RE: Tentative Tract No.: 68196-CN
Related Case: None
Address: 9246 N. Cedros Avenue
Council District: 7
Community Plan: Mission Hills-
Panorama City-North Hills
Existing Zone: RA-1
ENV-2006-3847-MND

In accordance with provisions of Section 17.03 of the Los Angeles Municipal Code, the Advisory Agency approved Tentative Tract No. 68196-CN composed of 1-lot located at 9246 N. Cedros Avenue for a maximum 6-unit detached single-family condominium as shown on map stamp-dated October 20, 2006 in the Mission Hills-Panorama City-North Hills Community Plan. This unit density is based on the RD3 Zone. (The subdivider is hereby advised that the Municipal Code may not permit this maximum approved density. Therefore, verification should be obtained from the Department of Building and Safety which will legally interpret the Zoning Code as it applies to this particular property.) For an appointment with the Advisory Agency or a City Planner call (213) 978-1330. The Advisory Agency's approval is subject to the following conditions:

TENTATIVE TRACT NO. 68196

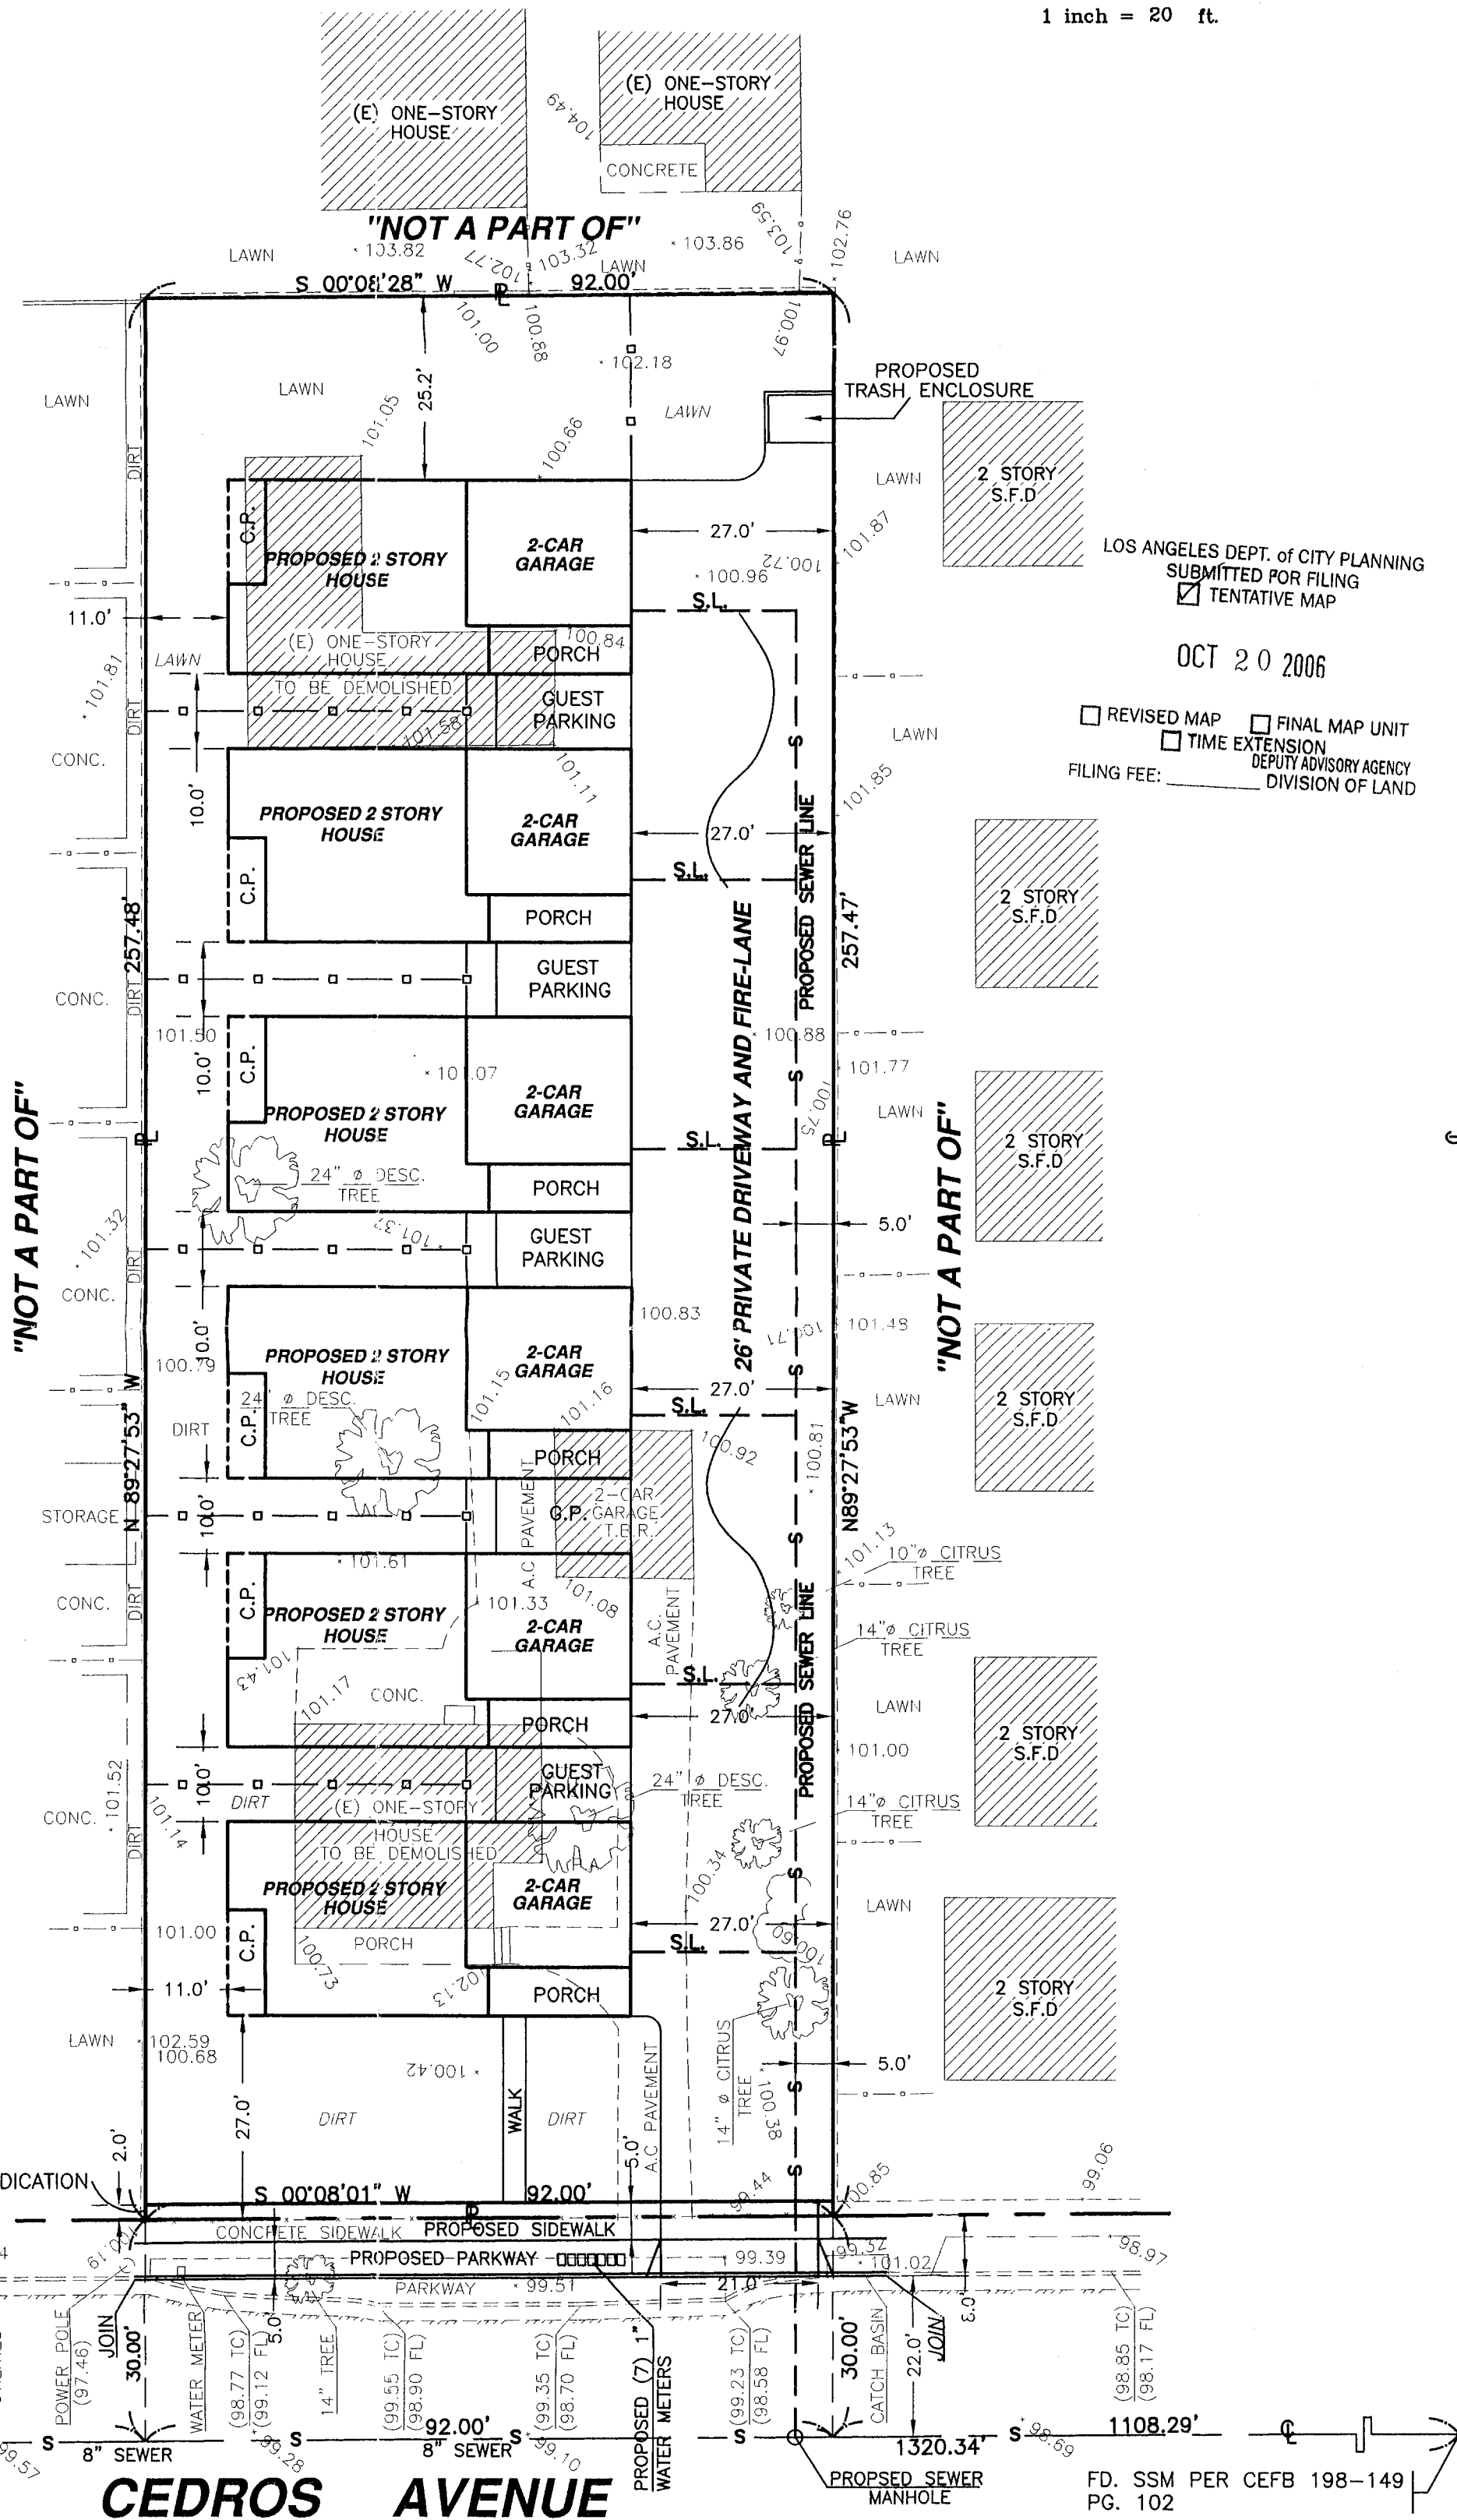
- a. Show all street dedication(s) as required by Bureau of Engineering and provide net lot area after all dedication. "Area" requirements shall be rechecked as per net lot area after street dedication.

- b. Obtain permits for the demolition or removal of all existing structures on the site. Accessory structures and uses are not permitted to remain on lots without a main structure or use. Provide copies of the demolition permits and signed inspection cards to show completion of the demolition work.

- c. The submitted map does not comply with the allowable use, minimum lot width, and lot area requirement of the A1-1 [sic] Zone. Revise the map to show compliance with the above requirement(s) or obtain approval from the Department of City Planning. A zone change approval is required for the proposed subdivision.
